PATENT APPLICATION

AMENDMENT UNDER 37 C.F.R. § 1.111
U.S. Application No. 09/653,070

AMENDMENTS TO THE DRAWINGS

Fig. 1

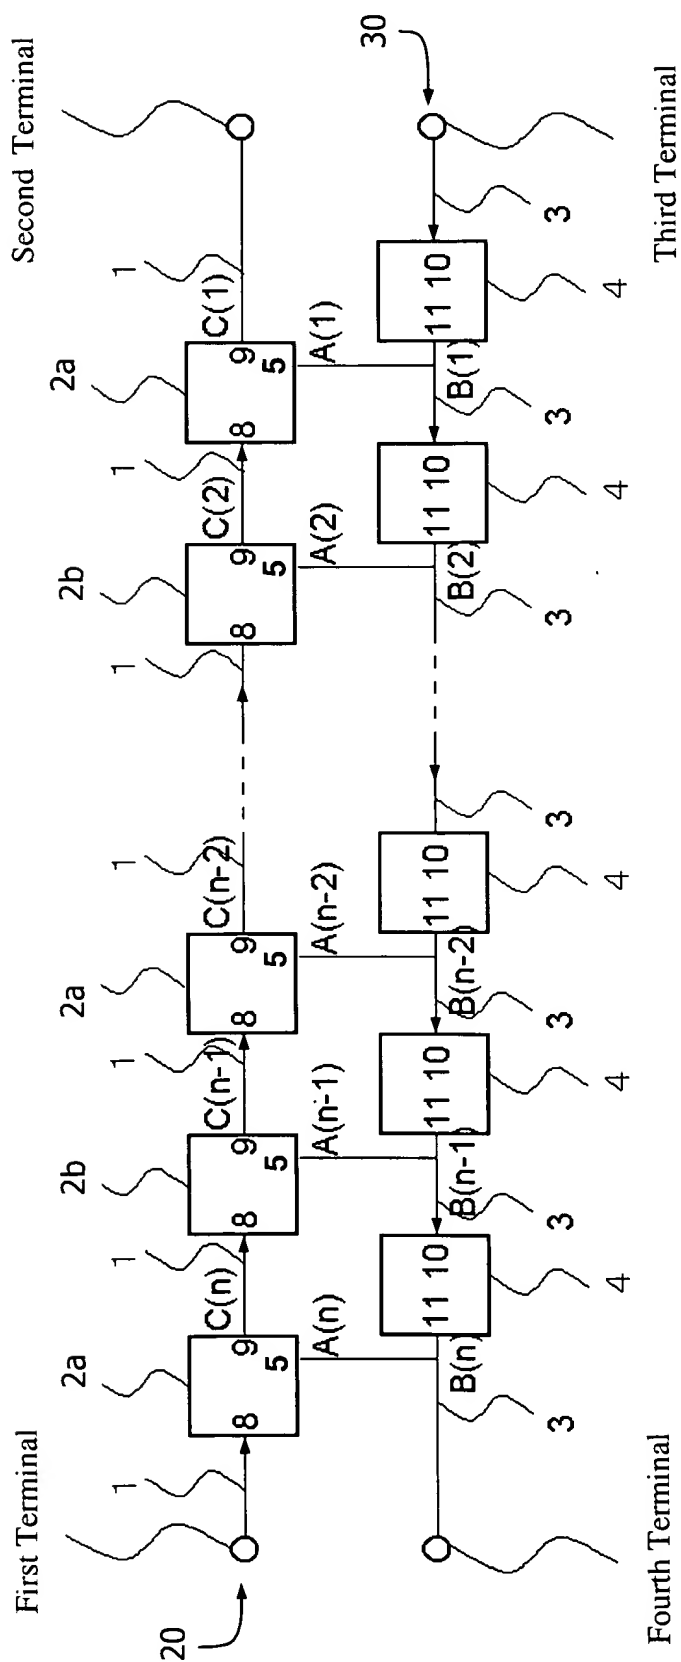
In Figs. 1 and 11, reference numbers “5” for congestion input terminals have been moved into blocks for data driving circuits 2a and 2b.

In Fig. 1, arrows have been added to the data line 20 and the congestion line 30 to indicate the direction of the data flow and congestion signals.
